Johnson Creek Floodplain Zoning Code Maintenance

Revising the Johnson Creek Basin Plan District
to Incorporate the Most Current FEMA Flood Maps

Exhibit A: Planning Commission Report and Recommendations to the City Council

Adopted by the Portland City Council
July 9, 2003, Ordinance No. 177689

LEGEND

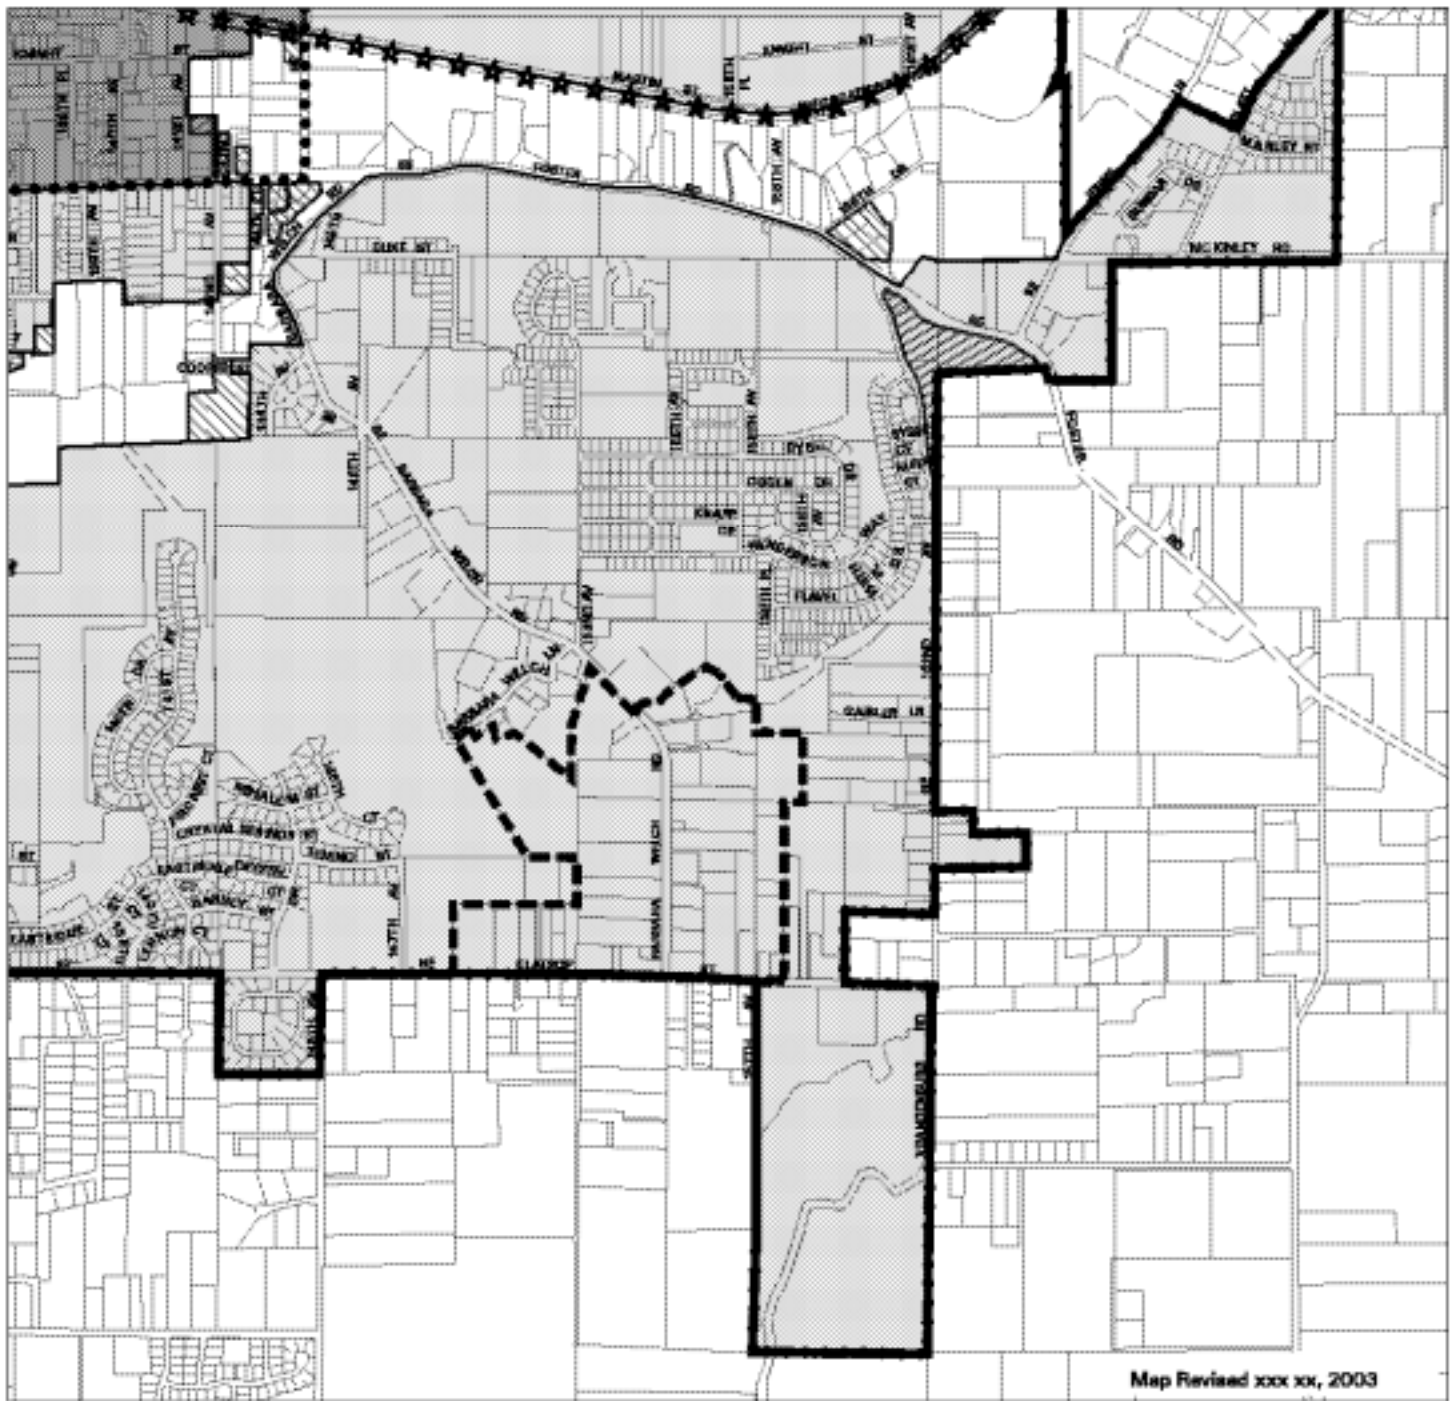
This second set of maps includes additional information to help readers understand the proposals in this report. This information will not be included on the official *Zoning Code* maps. These maps show all the sites that have been removed from, or added to, the floodplain as a result of FEMA's update. The maps also show the Kelly Butte and Johnson Creek Flood Plain subdistricts with a note in the legends that explains that the Johnson Creek Flood Plain subdistrict will no longer be identified on the zoning maps and the Kelly Butte subdistrict will be eliminated.

Map 631-1

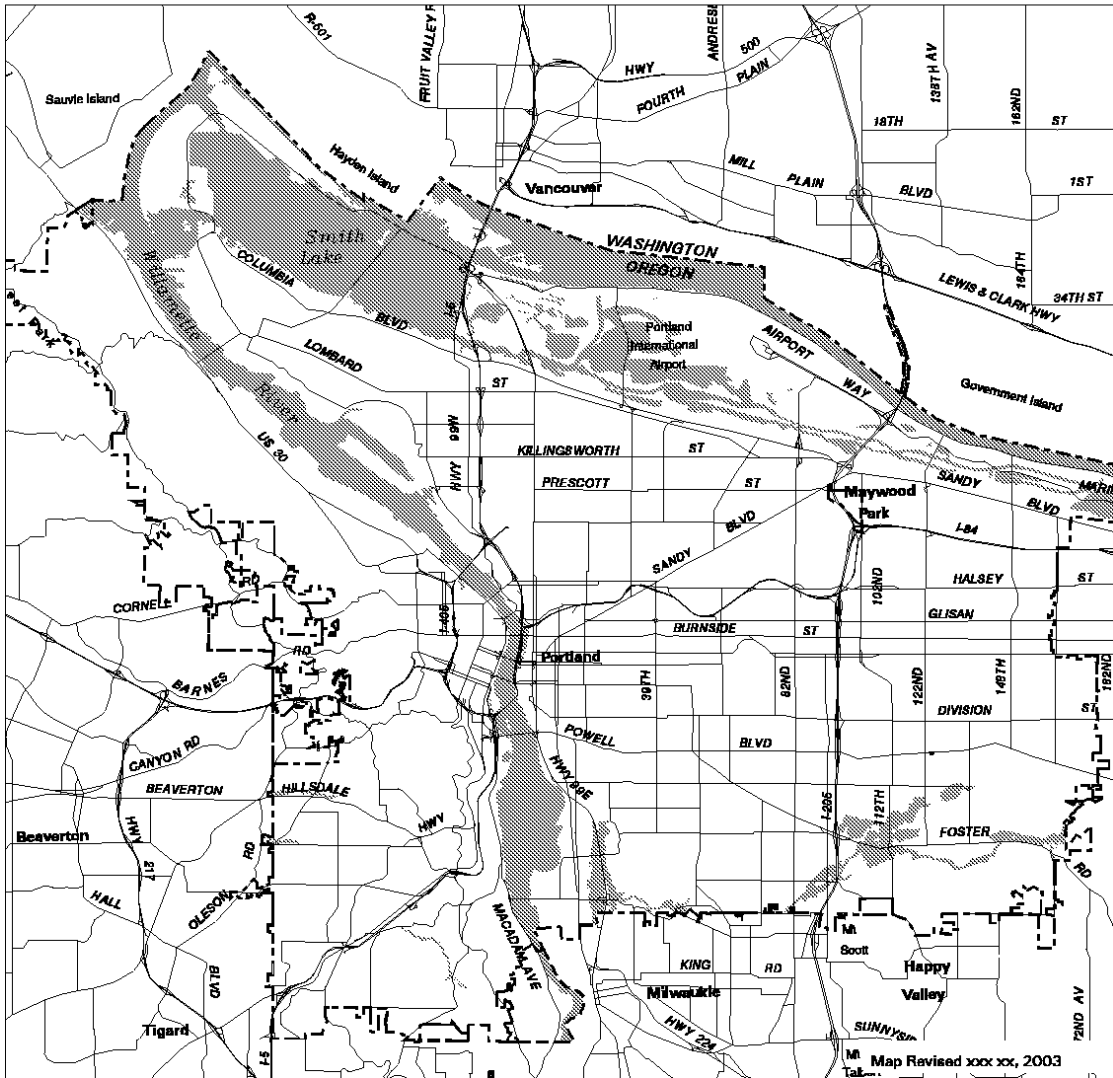
Map 631-1, Potential Flood Hazard Area Map has been revised to reflect the updated FEMA 100-year floodplain boundary in the Johnson Creek watershed. In the Johnson Creek watershed, the 100-year floodplain boundary was the criteria for determining the boundaries of the potential flood hazard area. The amendments to Map 631-1 only affect the Johnson Creek watershed.
